Application for Licence Amendment

Licence Number	L8676/2012/1
Licence Holder	AngloGold Ashanti Australia Limited
ACN	008 737 424
File Number	2012/002666-3~6
Premises	Tropicana Gold Mine Legal description Part of M39/1096 As defined by the Premises maps attached to the Revised Licence
Date of Report	4 June 2024
Decision	Revised licence granted

On 24 October 2023 AngloGold Ashanti Australia Limited (the Licence Holder) submitted an application to the department to amend L8676/2012/1 under section 59 and 59B of the *Environmental Protection Act 1986* (EP Act). The application is seeking approval to construct and operate a new in-pit Tailings Storage Facility (TSF) within the existing Havana South Stage 2 open pit (HSS2) at the Tropicana Gold Mine.

Figure 4: Predicted water levels (December 2028) Source: Groundwater Consulting Pty Ltd 2023

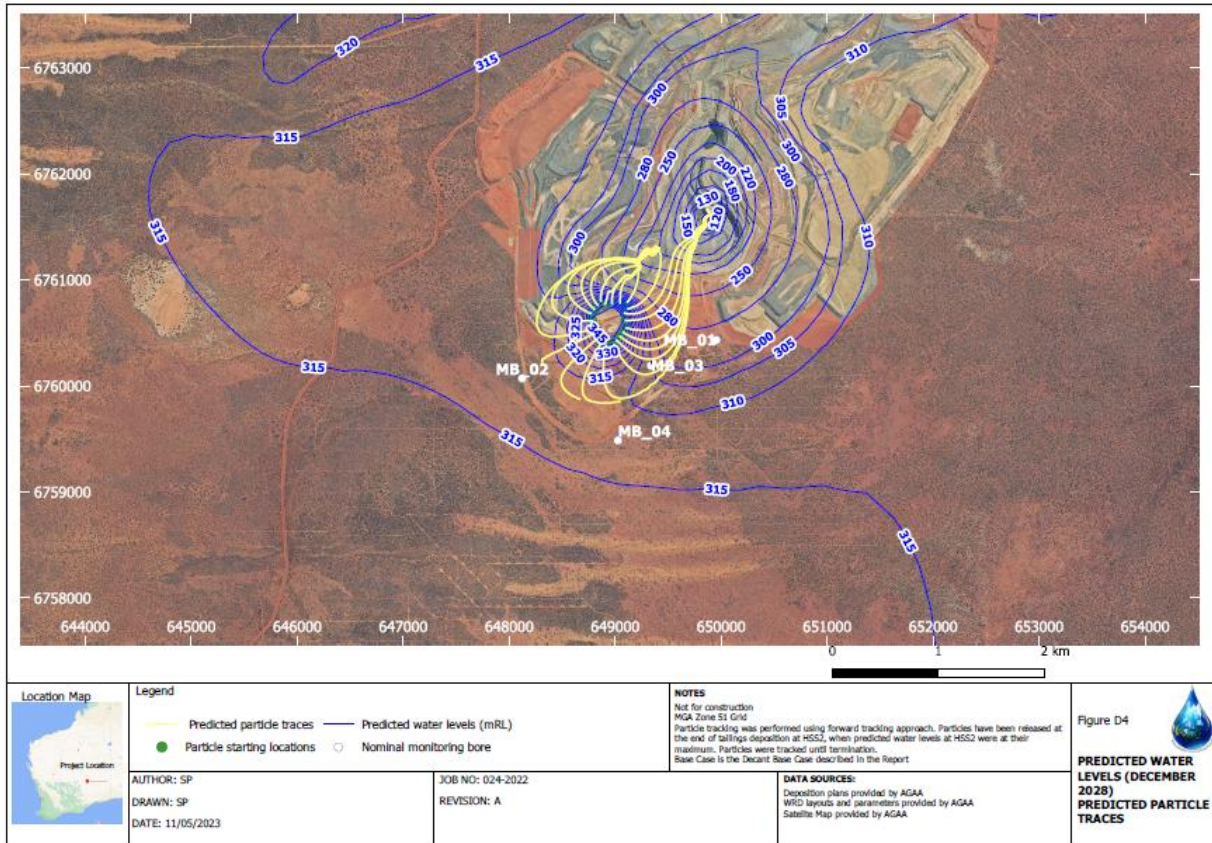
A technical review of the models has been undertaken. The Department considers that the choice of models is generally appropriate and that the general trend of changing groundwater levels near HSS2 is likely to be correct. However, a number of issues have been identified with how the modelling was undertaken that is likely to reduce the accuracy of the predicted groundwater levels.

The Licence Holder has based the predicted rate of groundwater flow between HSS2 and an adjacent mine void on the standard formulation of Darcy's Law. In this equation, the groundwater flow rate would be calculated assuming that groundwater potentiometric heads would decrease in a linear fashion with distance between HSS2 and the adjacent mine void. However, it is considered that it would be more likely that these levels would decrease approximately in a parabolic fashion between these two features, which would cause significant changes to the calculated groundwater flow rates.

Therefore, the department considers that the groundwater flow rates and potentiometric heads between the two mine voids during tailings disposal would be better estimated using the Dupuit-Forcheimer equation. This is because this equation of groundwater flow assumes parabolic variations in potentiometric heads take place with distance between water bodies that contain water at different elevations.

The Licence Holder appears to have assumed an evaporation rate that applies to the evaporative loss of water from the surface of a freshwater body, not from the hypersaline water that would probably be present in the decant pond in the HSS2 facility.

Therefore, it is suggested that the evaporation rate in both models that were developed for HSS2 have been greatly over estimated and consequently, it is likely that the seepage rate from the facility, and the degree to which local groundwater mounding would take place, will be higher than predicted by the model.

However, seepage modelling has indicated that ongoing dewatering of the neighboring Havana open pit will create a drawdown effect resulting in any seepage migrating towards and being captured by Havana open pit (Figure 4). It is also predicted that the Havana open pit will remain as a groundwater sink in the long term.
